**CONCEPT PLAN FOR A RESIDENTIAL DEVELOPMENT CONCEPT, 5 WHITESIDE  
STREET AND 14 & 16 DAVID AVENUE, NORTH RYDE**

**Planning &  
Infrastructure**

**Figure 12:** Photomontage of February 2013 Amended Concept Plan -recommended height reduction shown in red

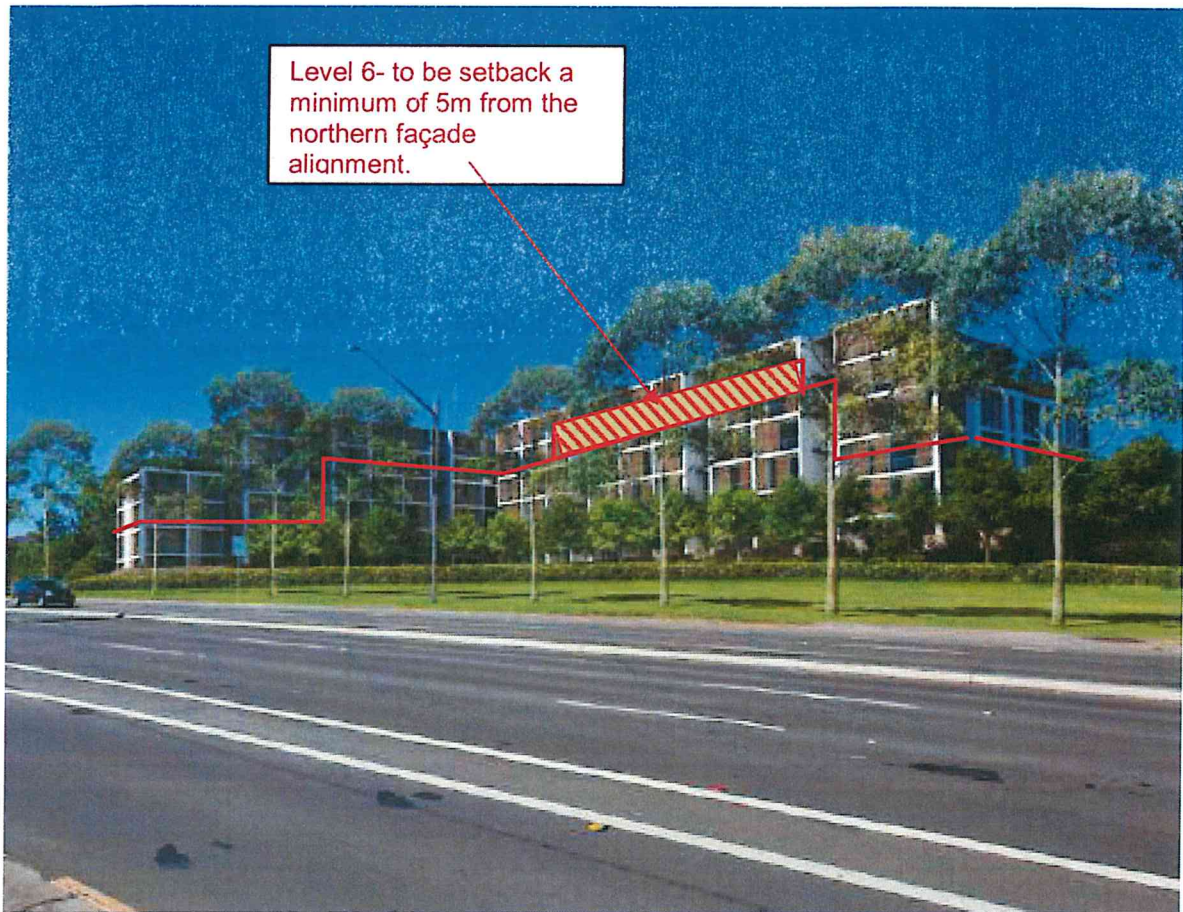
Therefore, on balance, it is considered that the form and scale of Building A should be further reduced to ensure that it provides a better urban response to its immediate low density residential context whilst permitting an increase in density over and above that which is currently permitted in Ryde LEP 2010. To address this, the department recommends the following amendments to the form of Building A:

- That the overall height of Building A be reduced predominantly to 3 storeys at the northern and western ends close to neighbouring residential boundaries.

- That 5 storeys be permitted only well within the site. Given the size of the site and its significant length to Epping Road, it is considered that a 5 storey form can be accommodated on the site without compromising the amenity of the neighbouring properties. This will also provide for an appropriate transition in height across the site.

- That a small element of 6 storeys be permitted, being setback a minimum of 5 metres from the northern facade. Again, this element is considered to provide an appropriate transition in height across the site and is centrally located on the building where the visual impact and amenity impacts can be minimised.

- That the proposed setback of 10 metres to the northern boundary be retained. This setback is considered appropriate in order to ensure Building A responds to the prevailing alignment of buildings along the southern side of the Epping Road and to provide for suitable landscape embellishment.

A marked-up photomontage and a floor plan showing the height reductions for Building A are provided at **Figures 12 and 13** below.

The amended form for Building A, is recommended in the terms of approval. The department notes that as part of the future development application, the final architectural detailing of a building will be required.

**Figure 16:** Proposed Site Access

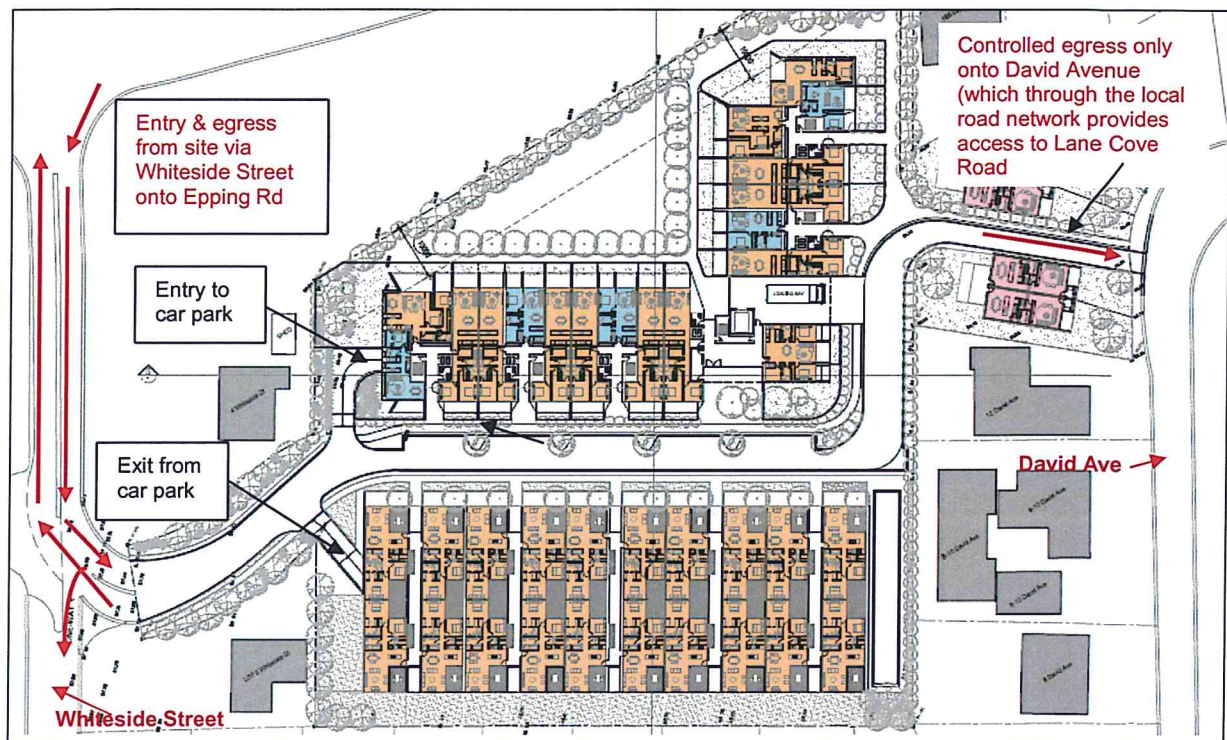
The concept plan seeks to provide vehicular ingress and egress to the site via the following means, as illustrated in **Figure 16**:

With respect to the access arrangements for the site, it is noted that there have been submissions received objecting to the internal access road to David Avenue. The PB Traffic Study has considered this matter and has concluded that the David Avenue access is essential to provide for alternative access to the site in the event that the county road reservation is implemented in the future. Furthermore, it concludes that the David Street access will assist in distributing traffic impacts on the local road networks as opposed to concentrating all traffic impacts associated with access and egress from the site on Whiteside Street.

Having considered the advice provided by Parsons Brinkerhoff, the department is satisfied with the access design and has recommended appropriate requirements to reinforce and stipulate these design requirements for the David Avenue exit.
